From: Andrew Leon <andrew.leon@mercerisland.gov>
Date: Friday, June 18, 2021 at 6:09 PM
To: Chris Niederman <Chris@niederman.com>
Cc: Mercer Island ePermit Tech <epermit.tech@mercergov.org>
Subject: 2015-227 Planning Review Comments

I have completed my first round of review of your building permit to install an automatic electric gate at 6800 96th Ave SE, as process under permit number 2105-227. I have the following review comments:

PROJECT: NIEDERMAN
6800 96TH AVE SE
MERCER ISLAND, WA 98040

DRIVEWAY ELEVATION VIEW
SCALE 1/8" = 1'-0"

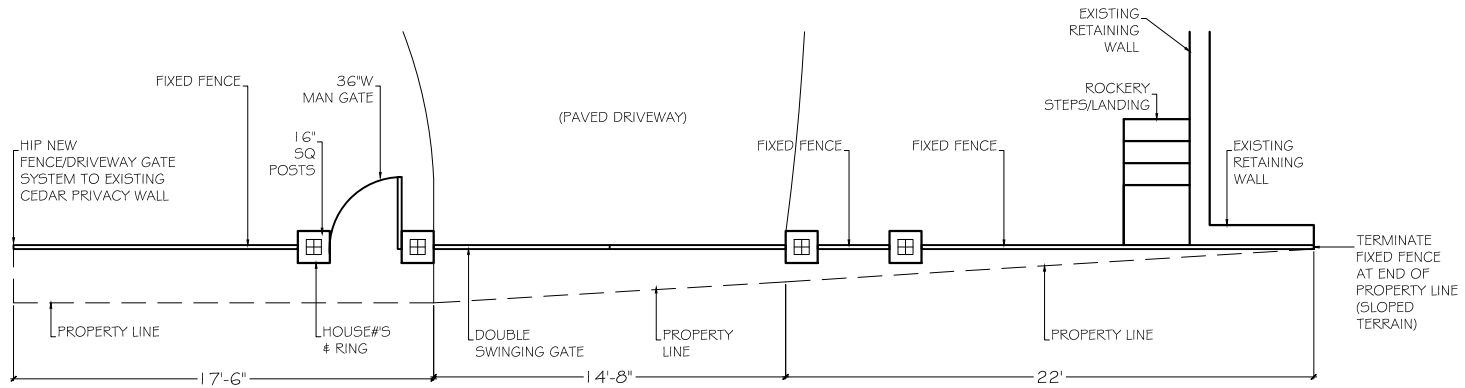
MIC 19.02.050(C)(1) states that the height of a fence is measured from the top of the fence, including posts, to the existing grade or finished grade, whichever is lower, directly below the section of the fence being measured. The lights are part of the posts, so they would also need to meet the 72-inch height limit for the fence.

One question....if the top of the posts are at 72 inches then can we still put lights on top of the posts or do the top of the lights also need to be at 72 inches max?

- [MICC 19.02.050\(E\)\(1\)\(a\)\(i\)](#) states that fences and gates are allowed to a maximum height of 72 inches within required side yards. Further, [MICC 19.02.050\(C\)\(1\)](#) states that the height of a fence or gate is measured from the top of the fence or gate, including posts, to the existing or finished grade, whichever is lower, directly below the section of the fence or gate being measured.

The plans show that the posts of the proposed gate and fence are to be 78 inches in height, with elements extending above 78 inches. This exceeds the 72 inch height limit. Please revise the height of the posts so they meet the height limit listed in [MICC 19.02.050\(E\)\(1\)\(a\)\(i\)](#).

I received this set of drawings from Mr. Niederman today. They address my comments, so I have changed my review line in Trakit from WCI to Approved. These revised drawings should be added to the approved plan set.
